SUNDRY NOTICES AND REPORTS ON WELLS (DO NOT USE THIS FORM FOR PROPOSALS TO DRILL OR TO DEEPEN OR PLUG BACK TO A DIFFERENT RESERVOIR. USE "APPLICATION FOR PERMIT" (FORM C-101) FOR SUCH PROPOSALS.)		WELL API NO. 30-015-49896
1. Type of Well: Oil Well ☐ Gas Well ☒ Other		5. Indicate Type of Lease STATE ☐ FEE ☒
2. Name of Operator Mewbourne Oil Company		6. State Oil & Gas Lease No.
3. Address of Operator PO Box 5270 Hobbs, NM 88240		7. Lease Name or Unit Agreement Name Sunrise 31 WOMP Fee
4. Well Location Unit Letter <u>I</u> : <u>2470</u> feet from the <u>South</u> line and <u>210</u> feet from the <u>East</u> line Section <u>36</u> Township <u>22S</u> Range <u>26E</u> NMPM County <u>Eddy</u>		8. Well Number <u>1H</u>
11. Elevation (Show whether DR, RKB, RT, GR, etc.) 3205' GL		9. OGRID Number 14744
		10. Pool name or Wildcat PURPLE SAGE; WOLFCAMP GAS

Mewbourne Oil Company requests to make the following changes to the Sunrise 31 WOMP Fee #1H well:

¹ API Number 30-015-49896	² Pool Code 98220	³ Pool Name PURPLE SAGE; WOLFCAMP (GAS)
⁴ Property Code 333209	⁵ Property Name SUNRISE 31/32 WOMP FEE	⁶ Well Number 1H
⁷ OGRID NO. 14744	⁸ Operator Name MEWBOURNE OIL COMPANY	⁹ Elevation 3205'

O

WELL LOCATION AND ACREAGE DEDICATION PLAT

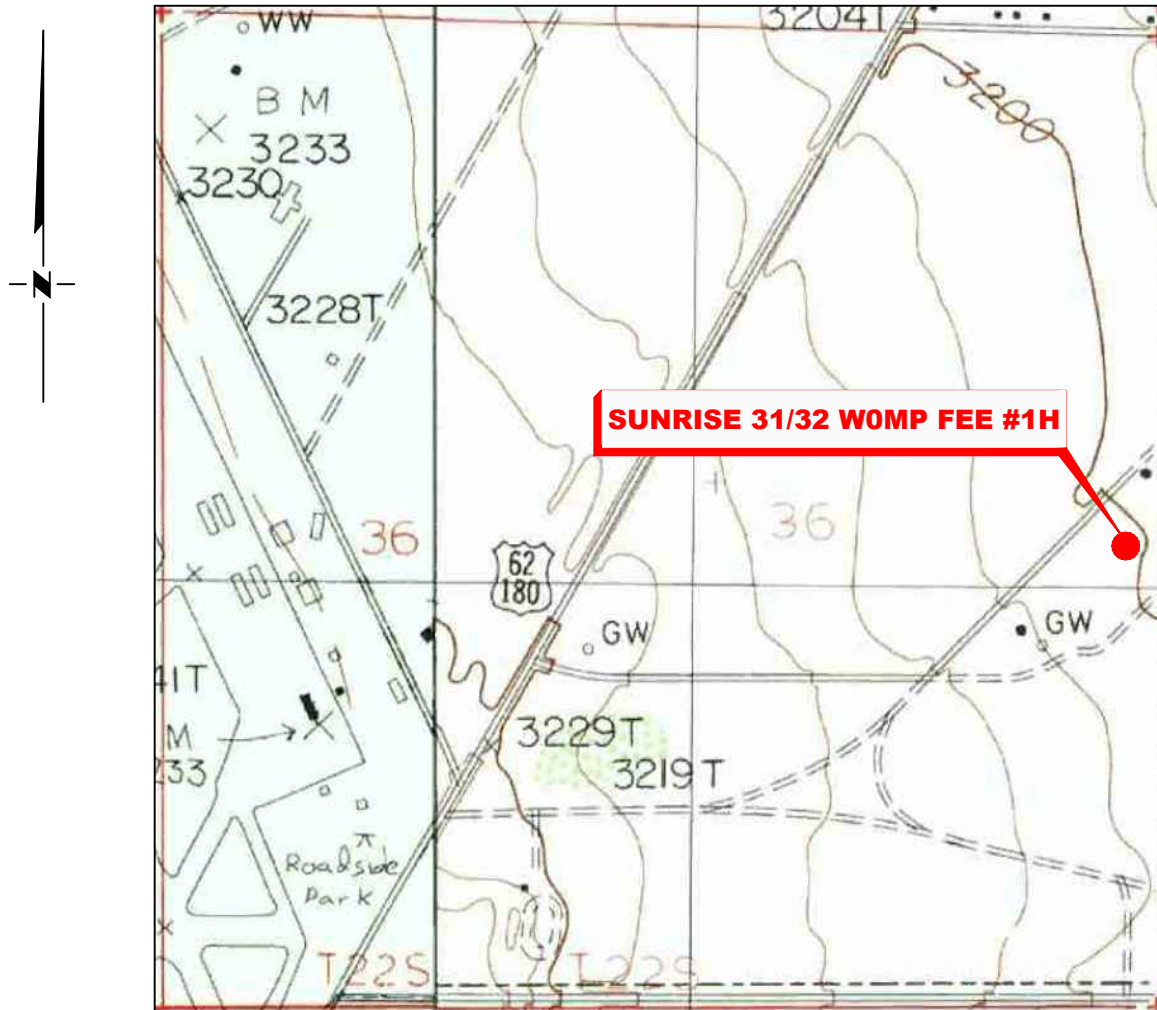
2: Extend lateral section from 1 mile to 2 mile. BHL change from 660 FSL & 330 FEL (Sec 31, T22S, R27E) to 990 FSL & 100 FEL (Sec 32, T22S, R27E).

Changes to casing, cement, and direction plan are included in attachments along with updated C-102 well plat.

UL or lot no.	Section	Township	Range	Lot Idn	Feet from the	North/South line	Feet from the	East/West line	County
P	32	22S	27E		990	SOUTH	100	EAST	EDDY
